SUBJECT: COMANCHE PEAK STEAM ELECTRIC STATION (CPSES)
DOCKET NOS. 50-446
TRANSMITTAL OF INSERVICE INSPECTION PROGRAM PLAN
INTERIM CHANGE REQUEST
(UNIT 2: 1986 EDITION OF ASME CODE SECTION XI, NO ADDENDA,
INTERVAL START DATE - AUGUST 3, 1993, FIRST INTERVAL)

Interim Change Request No. ISI-2R0-006

INTERIM CHANGE REQUEST

Plan Title/Rev. Unit 2 ASME Section II Inservice Inspection Program Plan 10 ICR No. 6

ILLUSTRATIVE USE ONLY THIS DIAGRAM DEVELOPED FROM FLOW DIAGRAM M2-0232	
TU ELECTRIC CPSES UNIT 2	
INSERVICE INSPECTION BOUNDARY DIAGRAM	
CONTAINMENT SPRAY SYSTEM SHEET 1 OF 4	
REV 2	APPROVED: <i>[Signature]</i> 12/18/95

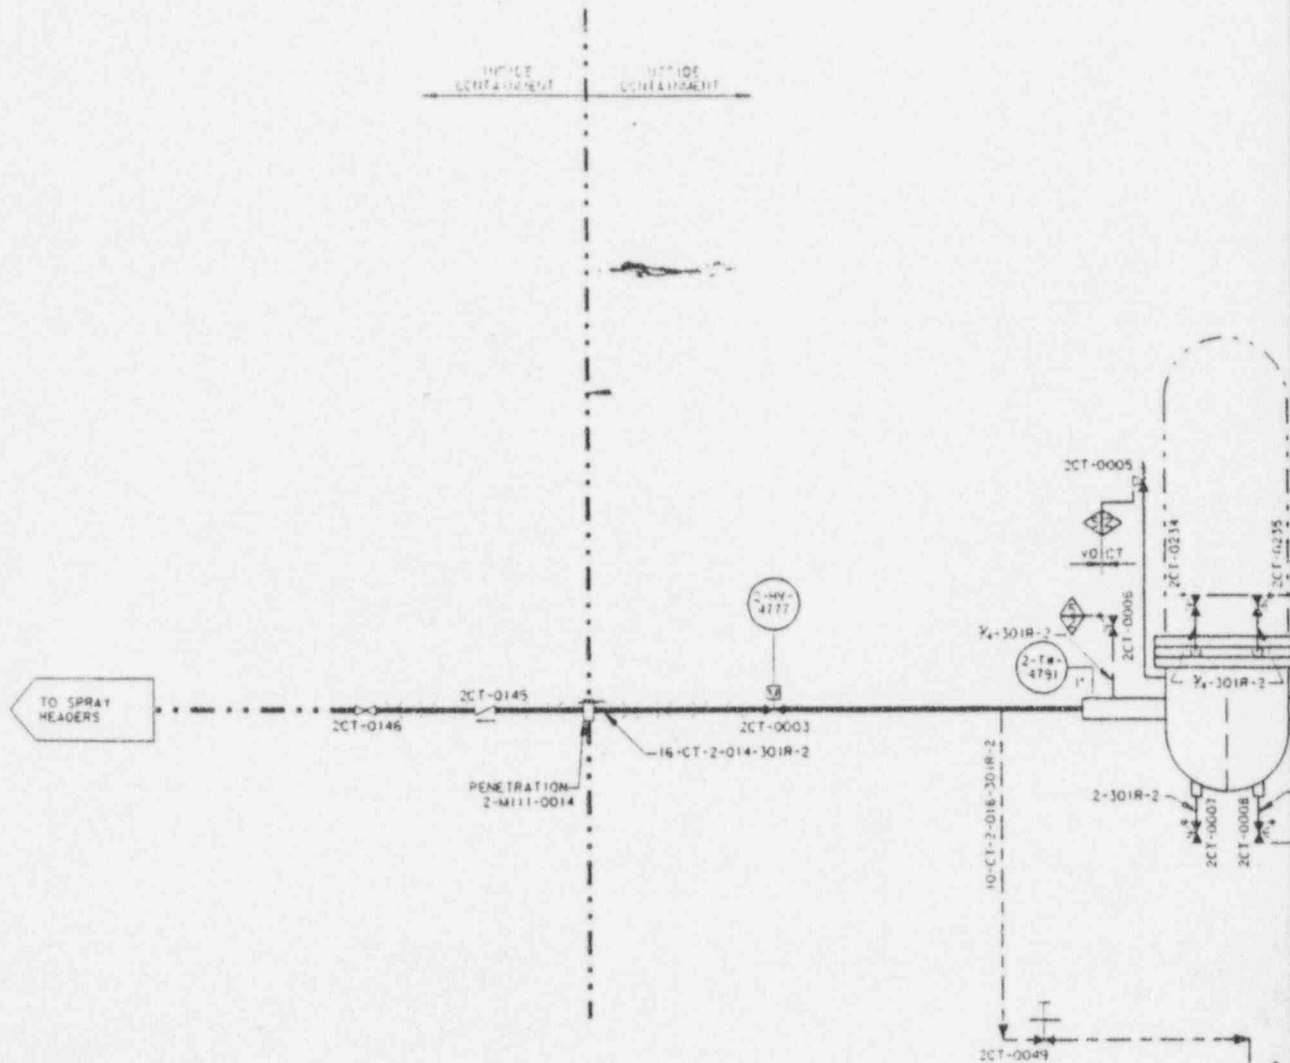
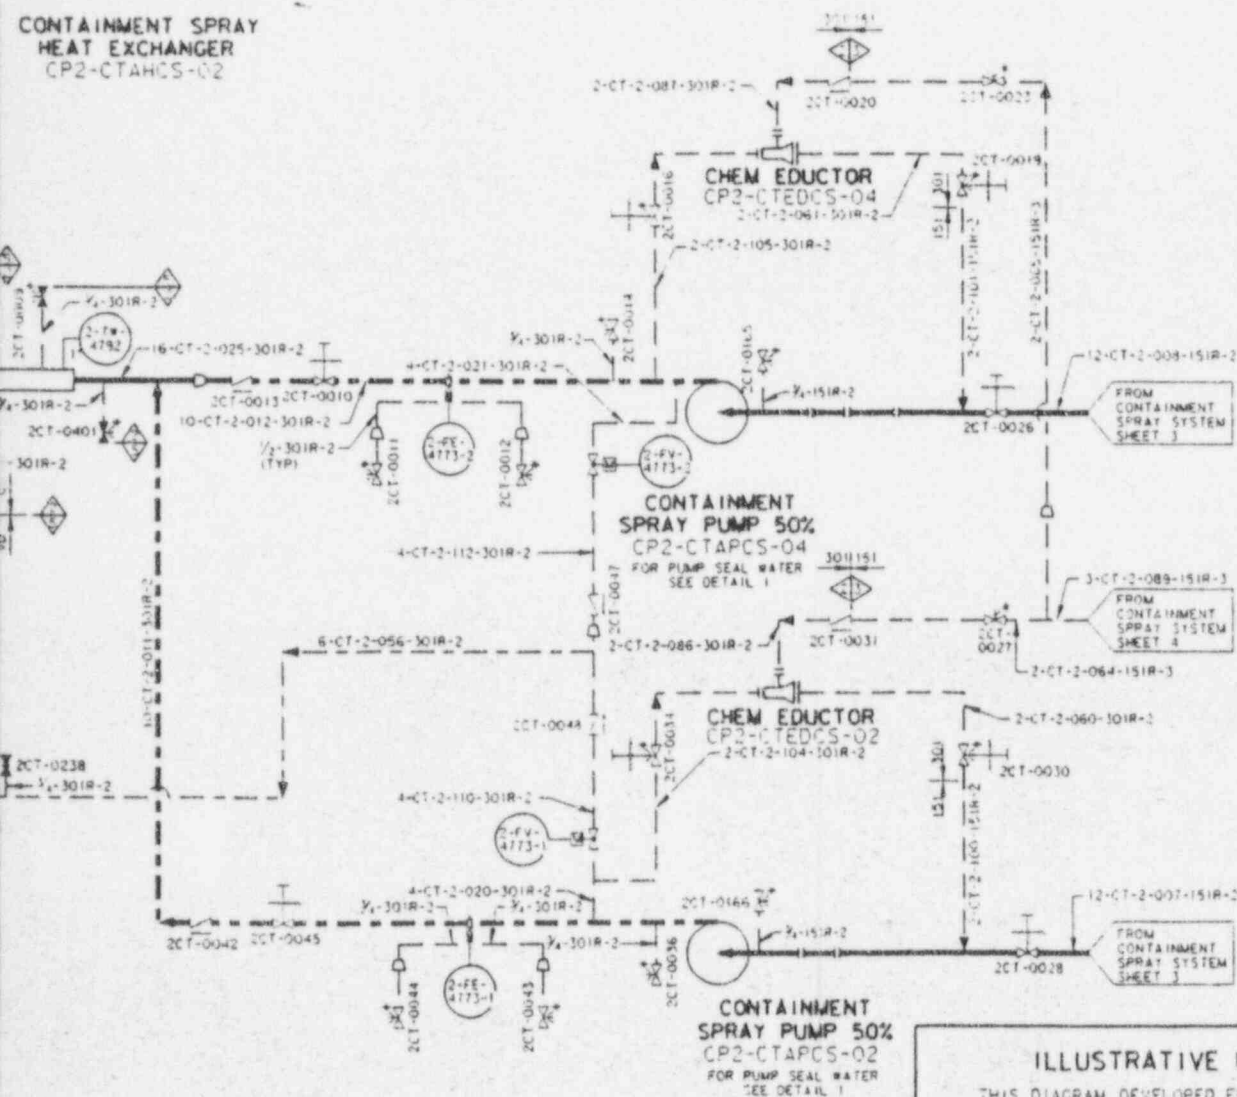
2. CT - The portion of the 16" CT header supply downstream of 2CT-003/052 has been reclassified as ISI only (i.e. removed the pressure test requirements). This is due to the fact that these portions of the CT system are considered as open ended in accordance with Category C-H, note (1). IWA-9000 defines open-ended as, "a condition of piping or lines that permits free discharge to atmospheric or containment atmosphere".

There are 2 valves between 2CT-003/052 and containment atmosphere. However, the manual valve 2CT-0146/0142 is locked open and the other is a check valve (2CT-0145/0142). The valve position of the locked closed valve and the operability of the check valve are periodically verified in accordance with station surveillance procedures.

Replace Table 9 of Section 5.0 with the attached. Replace the existing drawing with the attached drawings as listed below. A detailed justification of this change is attached.

COMPONENT COOLING
WATER SYSTEM
SHEET 2 OF 9

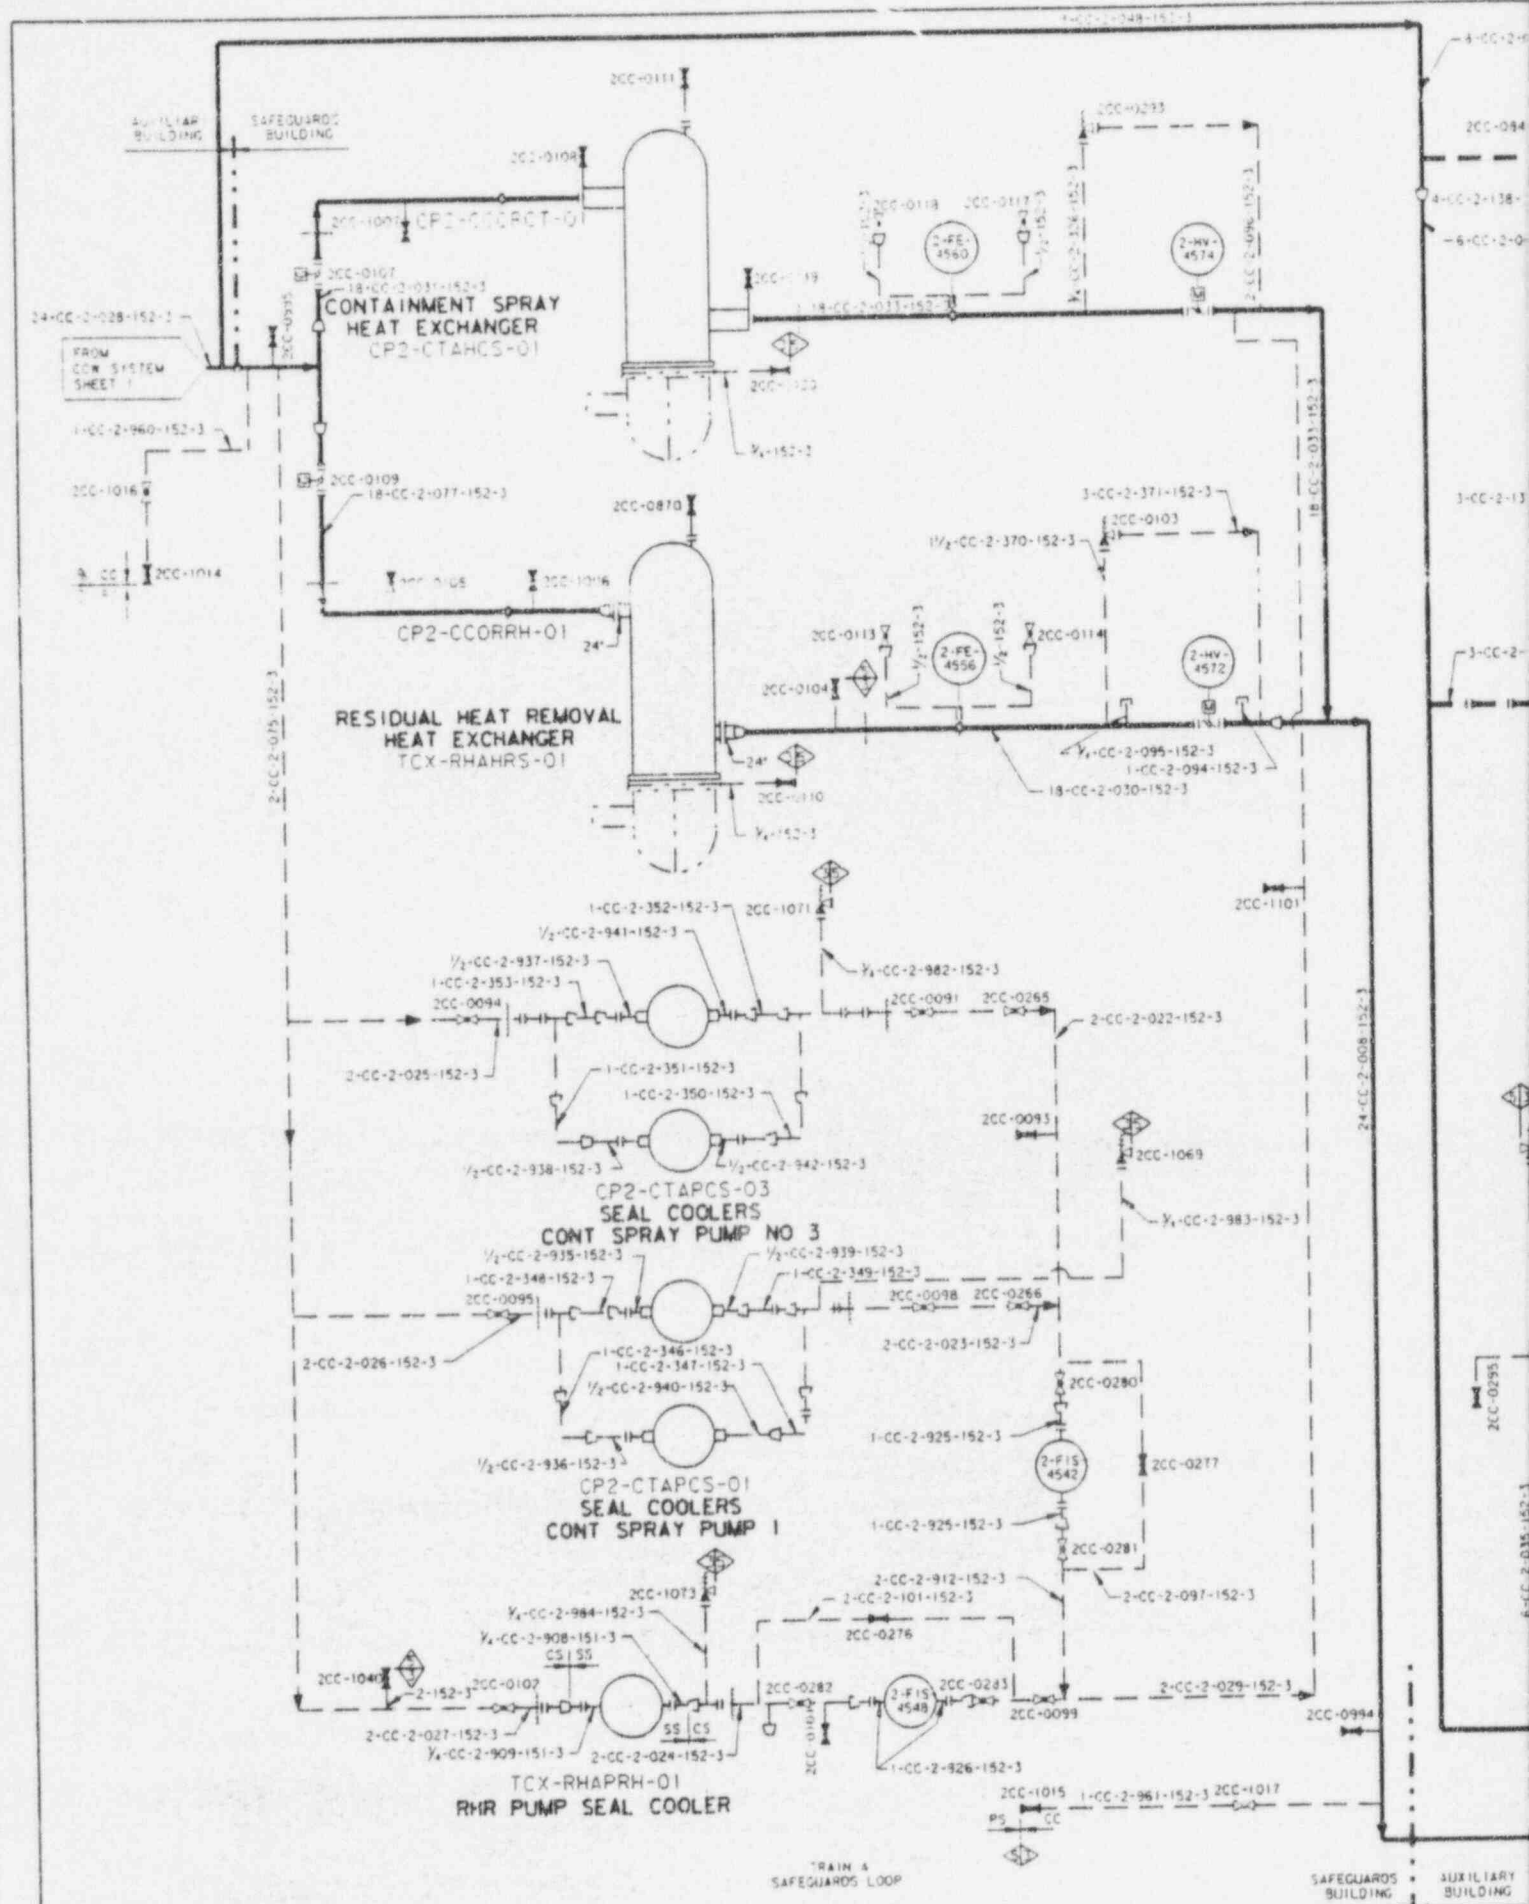
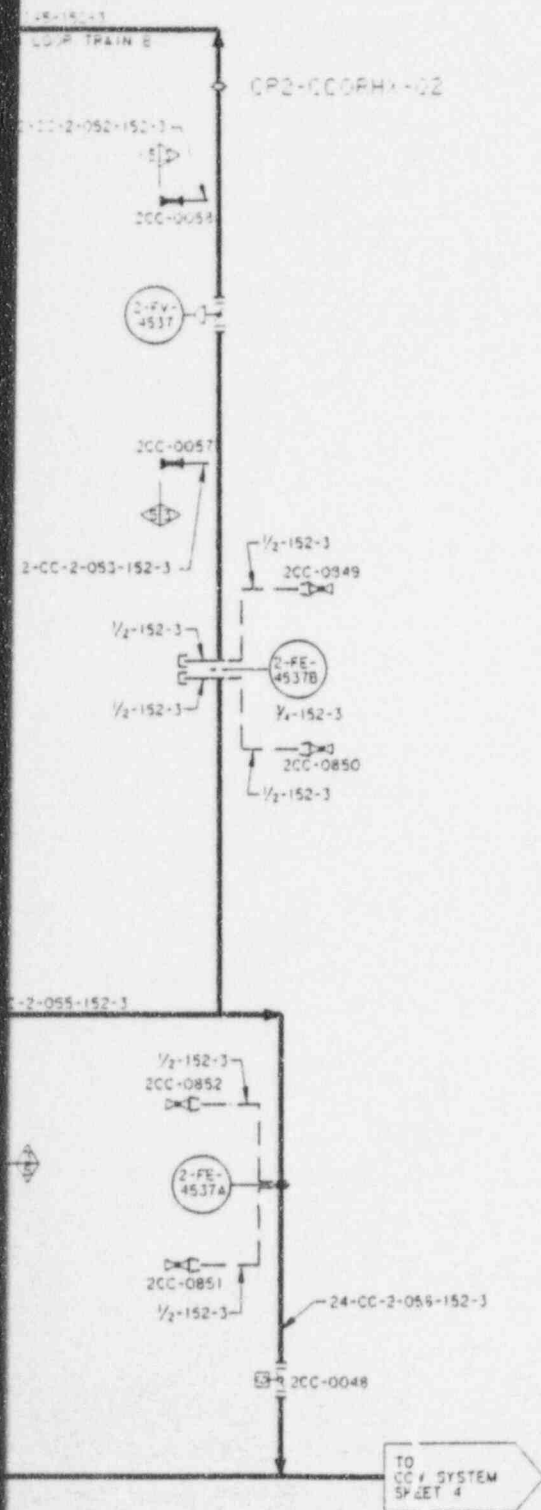
1. CC - Three 24" crossties are provided between Units 1 and 2. Each crossties is between locked closed butterfly valves. As described in DBD-ME-229, these crossties are not required for any design base accident or safe shutdown. Therefore they do not meet any of the criteria established in Table D-A, D-B or D-C.

The portion of CC which is between containment isolation valves 2-HV-4711 and 2-HV-4710 (both ORC) supplies flow to the shell side of the Reactor Coolant Drain Tank Hx and the Excess Letdown Hx. The Excess Letdown Hx accommodates expansion related flow in excess of the capabilities of normal CVCS letdown during plant heatup. The Reactor Coolant Drain Tank is part of the Waste Processing (WP) system. As described in DBD-ME-264, "Liquid Waste Processing System", the WP system does not perform a safety function. Valves 2-HV-4710/4711 close upon an S-signal. Therefore, the requirements of Category C-H note (7) are met.

PROCESS SAMPLING SYSTEM
SHEET 1 OF 1

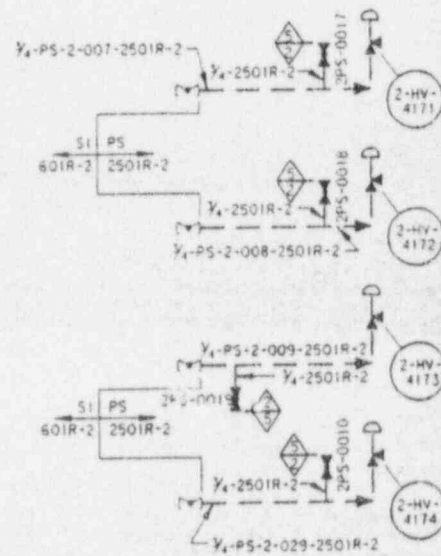
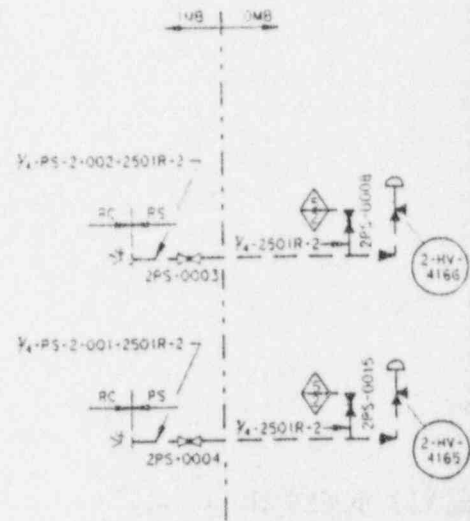
3. PS - Process sampling (PS) provides samples for monitoring RHR pump discharge chemistry. An active isolation valve is available in each sample train. As described in DBD-ME-228, "Process Sampling System", these valves close in the event of an accident. Therefore, the requirements of Category C-H note (7) are met.
4. RC - The primary side channel head drain on each steam generator is not classified as ASME Code Class. It is rather classified as ANSI safety class 2 instrumentation. As such these drains are not under the jurisdiction of ASME Section XI. Furthermore, these drains are scheduled for removal during 2RFO2 and 2RFO3 under minor modification 94-237. This minor mod will remove and plug each of the drains.
